RESOLUTION NO. 26062

A RESOLUTION APPROVING A PROPOSED FINAL PLANNED UNIT DEVELOPMENT SPECIAL EXCEPTIONS PERMIT FOR A PLANNED UNIT DEVELOPMENT KNOWN AS AMBERBROOK GARDENS PLANNED UNIT DEVELOPMENT ON PART OF A TRACT OF LAND LOCATED AT 5506 CASSANDRA SMITH ROAD, MORE PARTICULARLY DESCRIBED HEREIN AND AS SHOWN ON THE FINAL PLANNED UNIT DEVELOPMENT PLAN ATTACHED HERETO AND MADE A PART HEREOF BY REFERENCE, SUBJECT TO CERTAIN CONDITIONS.

P.U.D.: Amberbrook Gardens
Planned Unit Development
Lots 1-111

CASE NO.: 2005-077

AMBERBROOK GARDENS

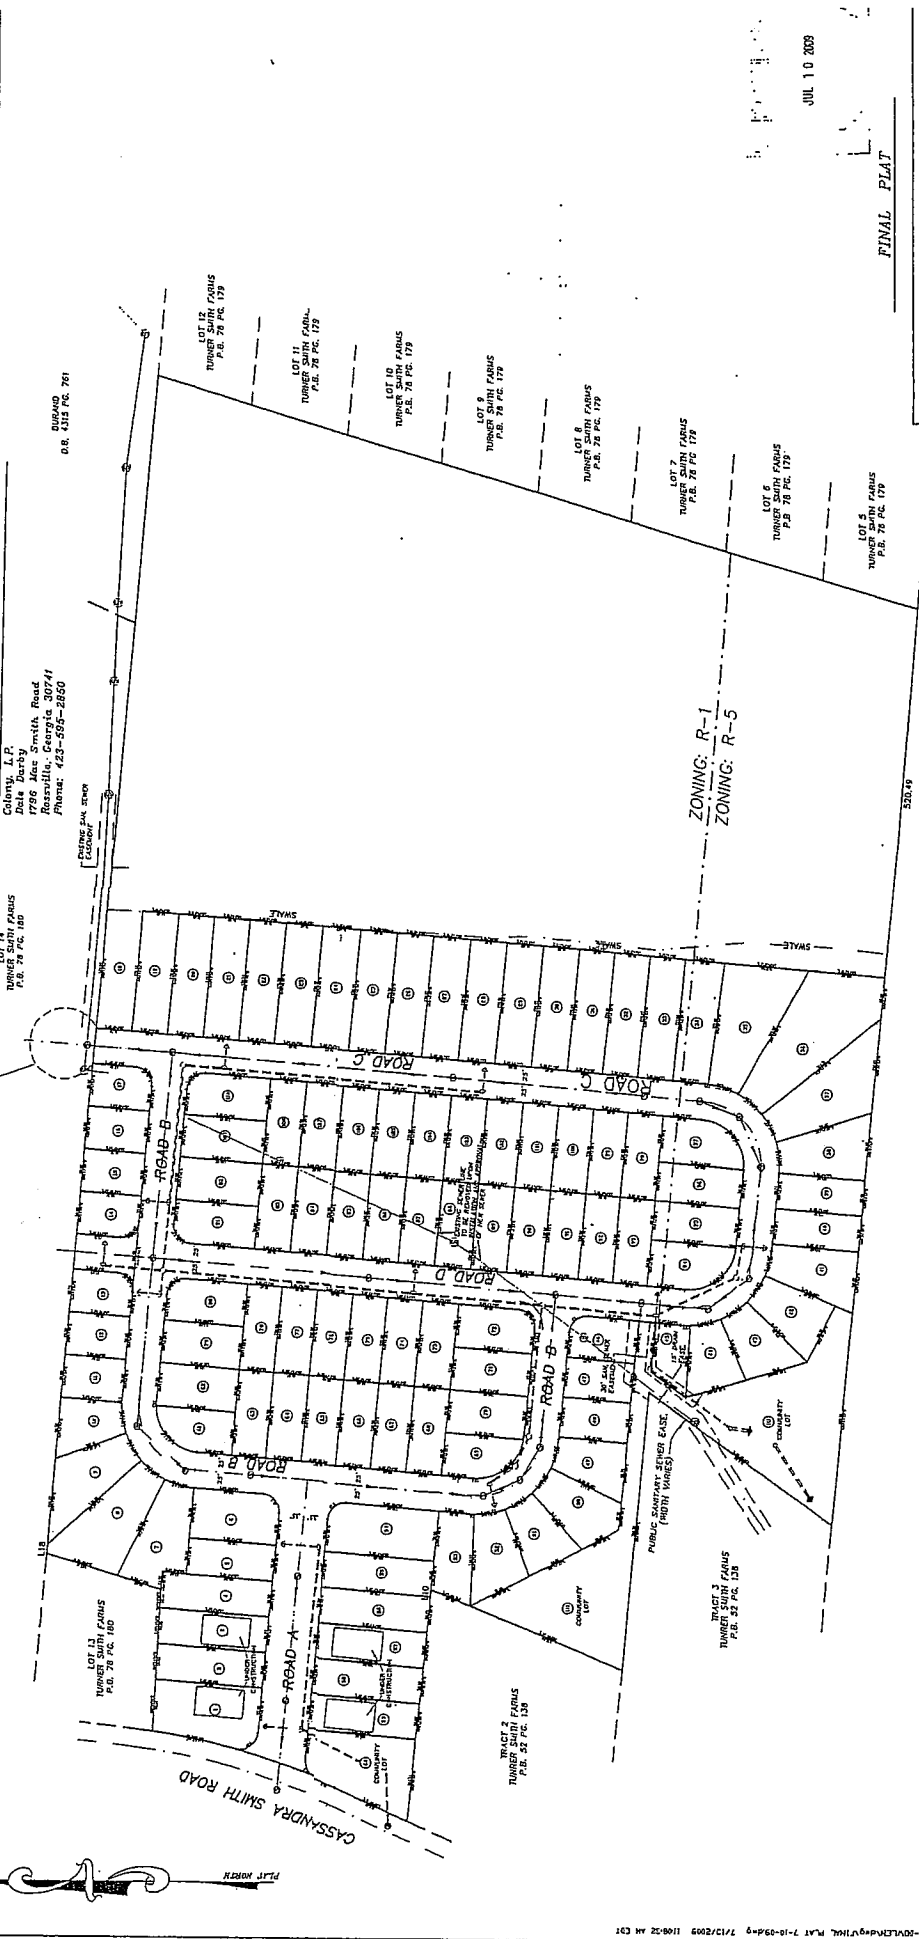
1. Label all road center lines as such.
2. Show the right-of-way width of Cassandra Smith Road.
3. Show the location and file number for the existing sewer line in Cassandra Smith Road.
4. Add the following note: "All buildings must be at least 25 feet from Cassandra Smith Road and other outer boundaries of this P.U.D. and at least 10 feet from other public roads and Future

5. Since there are more than 25 lots in this P.U.D., locate 2 boundary control monuments to minimum 1:20,000 accuracy in State Plane Coordinates and show the location and coordinates of these two boundary control monuments.

6. Article 5, Division 25, Section 38-297(2) of the Chattanooga Zoning Ordinance requires sidewalks or an equivalent paved internal pedestrian circulation system. Accordingly, show the location of the required sidewalks or equivalent paved internal pedestrian circulation system or add the following note: "Per requirements of the Chattanooga Zoning Ordinance, sidewalks are required on both sides of all internal streets except on any entrance island between lots 1-5 and 55-60".

7. Change "Final Plat" to "Final Planned Unit Development Plan".
8. Show exact bearings and distances for all straight lot lines and length, radius, tangent distance and delta angle for all curved lot lines.

9. Show the exact distance from lot 1 to Heritage Ridge Drive.
10. Delete note 3.
11. Add the following note: "Local Government does not certify that utilities or utility connections are available".

12. The area at the south end of the development shown as zoned R-5 has been rezoned to R-1. Consequently, delete the former R-1/R-5 zoning line.
13. Due to requirements of Article 5, Division 25, Section 38-399(3) of the Chattanooga Zoning Ordinance, Community Lots 60 and 111 do not count toward the open space requirement since they do not meet the open space requirements of that Section. Consequently, show lot 18 as a community lot and label it as an "Open Space" or see No. 59 below.

15. On Community Lots 60 and 111, show Private Drainage Detention Area Easements and City of Chattanooga Inspection Access Easements for the drainage detention areas shown on the Stormwater and Erosion Control Plan.

18. Show 15' private drainage easements along proposed drainage pipes in Community Lots 60 and 111.
19. Add the following note: "The City of Chattanooga reserves the right to access at any time the Private Drainage Detention Area Easement and City of Chattanooga Inspection Access Easements, private drainage easements and public sanitary sewer easements in Community Lots 60 and 111 to inspect drainage detention areas and facilities".

20. In Lots 45 and 111, change "15' Drain. Easement" to "15' Private Drain. Easement".
21. In Lots 46, 47 and 111, change "30' San. Sewer Easement" to "30" Public San. Sewer Easement".

26. Change the 60' radius temporary cul-de-sac to a 50' radius temporary cul-de-sac since the cul-de-sac is less than 150' long.
27. Note that a maximum of 110 detached, single-family dwelling units are permitted with a density of 2.7 units per acre.

32. There is an existing sewer line through Lots 17, 83-89, 108, 109, 46 and 47. The easement for this line must be abandoned by the Chattanooga City Council following a recommendation by the Planning Commission. The applicant or his representative must submit a request to the Regional Planning Agency for a recommendation to the City Council about the abandonment of the easement for the existing sewer line or the Chattanooga City Engineer must submit a request for a recommendation about this abandonment before this P.U.D. plan can be recorded.

40. The lot bearings, dimensions and curve data are printed too small to read. Print this information larger.
41. Label the road right-of-way between lots 13 and 14 as a Utility Easement and Future Road.

42. Show the sizes of all drainage pipes in road right-of-ways.
43. Show the number of acres drained for all drainage pipes which cross road right-of-way center lines.

44. Show a 10' private drainage easement for the swale in lots 18-33.
45. Show the size, location and number of acres drained for the drainage pipe installed in Cassandra Smith Road at Road "A".

46. Delete note 13 since No. 39 above includes it.
47. If there is to be an entrance island in Road "A", show it on the P.U.D. plan.
48. If there is to be an entrance island in Road "A" at the sewer line, add the following note: "That part of the entrance island within 10' of the public sanitary sewer is a public sanitary sewer easement. No structure of any kind is permitted in the public sanitary sewer easement and the only planting permitted in the public sanitary sewer easement in the entrance island is grass or small shrubs".

55. Show a 15' private drainage easement along the drainage pipes in the Utility Easement and Future Road between Lots 13 and 14.
56. Delete the solid line between Cassandra Smith Road and Road "A" since both will be public roads.

57. Note on the P.U.D. plan the resolution number for Final P.U.D. plan approval by the City Council.
58. If there is to be no entrance island within 100' of Cassandra Smith Road, Section 302.3.4.1.1 of the Chattanooga Subdivision Regulations requires a minimum 30' of paving from inside of curb to inside of curb for at least 100' from Cassandra Smith Road. Thereafter, the width may be tapered to the width for the remainder of Road "A".

1. Per Section 306.5.1 of the Chattanooga Subdivision Regulations, all storm water drainage pipes under pavement and sidewalk areas must be reinforced concrete (RCP). Consequently, all drainage pipes shown must be reinforced concrete (RCP) except in Community Lots and in Lot 45.

1. The Final P.U.D. Plan approved by Resolution No. 24732, shows a 20' wide and 260' long entrance island in Road "A". This design is not acceptable.

2. The developer could choose to eliminate the entrance island. If there is no entrance island in Road "A", the right-of-way could be reduced to 50'.
3. If there is to be an entrance island, reduce the width of the island to a maximum 8' and pave at least 19' on each side of the entrance island measured from inside of curb to inside of curb.

4. The length of entrance islands can only be a maximum of 125' with a minimum 24' break between islands if there is to be more than one island.
5. Any entrance island or entrance island must end at least 25' from the right-of-way of Cassandra Smith Road and Road "B" as extended across the intersection.

1. Show on the plat and install a fire hydrant at the lot line between Lots 65 and 66 or in the entrance island within 25' of the right-of-way of Road "B" if there is to be an entrance island in Road "A" within 25' of the right-of-way of Road "B". This

- a. at the lot line between Lots 79 and 80 or the lot line between Lots 12 and 13
 - b. at the lot line between Lots 41 and 42 or the lot line between Lots 94 and 95

- c. at the lot line between Lots 27 and 28 or the lot line between Lots 103 and 104
3. Show fire hydrants in their installed locations in the road right-of-way.

1. Show a 10' Power and Communication Easement along both sides of Roads "A", "B", "C" and "D".
2. Show a 10' Power and Communication Easement in Lots 13 and 14 along the Future Road.
